UNITED STATES PATENT AND TRADEMARK OFFICE

APPLICATION NO.	FILING DATE	FIRST NAMED INVENTOR	ATTORNEY DOCKET NO.	CONFIRMATION NO.
10/719,215	11/20/2003	Lucas Hendricus Robertus Maria Prinsen	VAND11	3193

Office Action Summary	Application No. 10/719,215	Applicant(s) MARIA PRINSEN ET AL.	
	Examiner Marcus Charles	Art Unit 3682

DETAILED ACTION

第 7 図

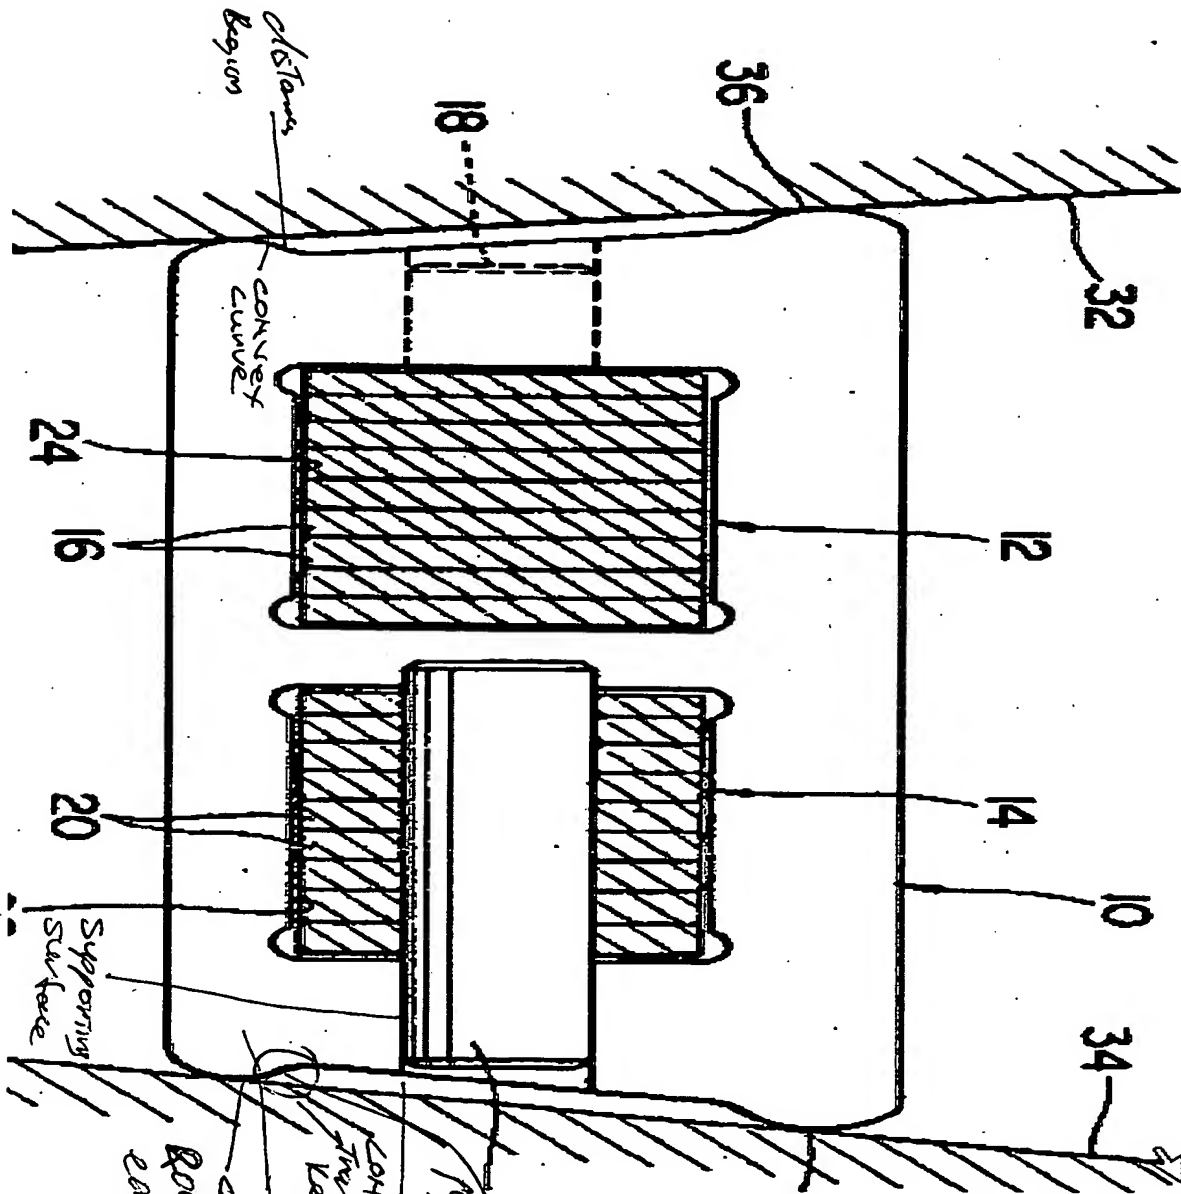
2. Claims 1-2, 9 and 11, as understood, are rejected under 35 U.S.C. 102(b) as being anticipated by JP (63-266248) to Anpo et al. Anpo et al. discloses transverse element comprising a supporting surface (see attached drawing), a pulley sheave contact surface (38), a transition region (see attached drawing in) which is connected to the supporting surface at one section and to the pulley sheave at another section, wherein the transition region inherently comprises a concave portion. Anpo et al. also disclose the concave region is in a plane perpendicular to the belt circumferential direction (see attached drawing)

In claim 2, note the transition edge region comprises a distance surface (see attached drawing) connecting to the pulley contact surface via the inherently concave portion.

THIS CONCAVE
portion is perpendicular
to the belt
turning
direction
